CALIFORNIA DEPARTMENT OF WATER RESOURCES

RE: Approved Determination of the Revised Groundwater Sustainability Plan Submitted for the Salinas Valley – Paso Robles Area Subbasin

**STATEMENT OF FINDINGS REGARDING THE
APPROVAL OF THE
SALINAS VALLEY – PASO ROBLES AREA SUBBASIN
GROUNDWATER SUSTAINABILITY PLAN**

State of California
Department of Water Resources
Sustainable Groundwater Management Program
Groundwater Sustainability Plan Assessment
Staff Report

Figure 1: Locations of interconnection between groundwater and surface water.

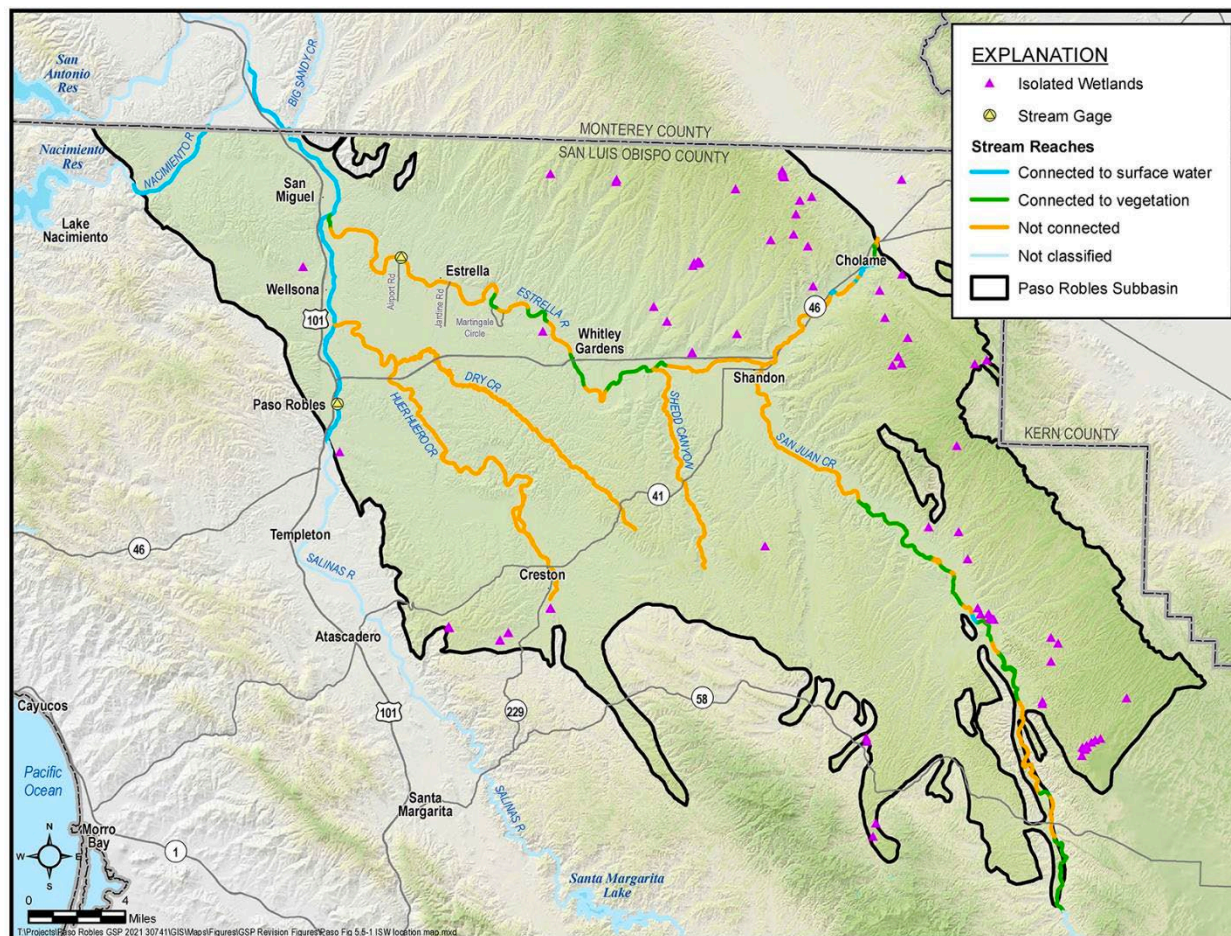
The GSP provides a map, Figure 1 below, depicting locations of interconnection between groundwater and surface water.⁵⁰

Staff consider the revised Plan to be generally improved but still missing information that should be included to improve clarity and completeness in addressing the GSP Regulations and facilitate staff evaluations of GSP and subsequent periodic evaluations. The Plan notes that pumping from the Alluvial Aquifer is “rare”, generally occurs to meet domestic and limited livestock water demands, and large-scale irrigation pumping does not typically occur.⁵¹ However, the GSP also states that the agricultural water use sector—which is the largest by volume⁵² with production wells located along the Salinas and Estrella Rivers⁵³—also pumps from the Alluvial Aquifer⁵⁴ without quantifying that volume. The GSP should provide specific volumetric quantities of estimated pumping that

occurs from the Alluvial Aquifer to detail the comparison of pumping from the Subbasin's two principal aquifers. Staff require this supporting information to assess whether the establishment of management criteria, which relies heavily on the claim that most groundwater pumping is from the Paso Robles Formation Aquifer, is a reasonable assumption. Additionally, while the GSP states analysis from *Methodology for Identifying Groundwater Dependent Ecosystems* indicates that groundwater pumping from the Paso Robles Formation Aquifer does not materially impact relevant groundwater dependent animals in Salinas River flows, the GSP does not discuss potential impacts of pumping from the Alluvial Aquifer on southern steelhead which migrate up and down the Salinas River in winter and spring. Department staff recommend the GSAs provide clear explanation of the usage of the Alluvial Aquifer and provide specific volumetric quantities of estimated pumping that occurs from the Alluvial Aquifer to detail the comparison of pumping from the Subbasin's two principal aquifers. (see [Recommend Corrective Action 4a](#)).
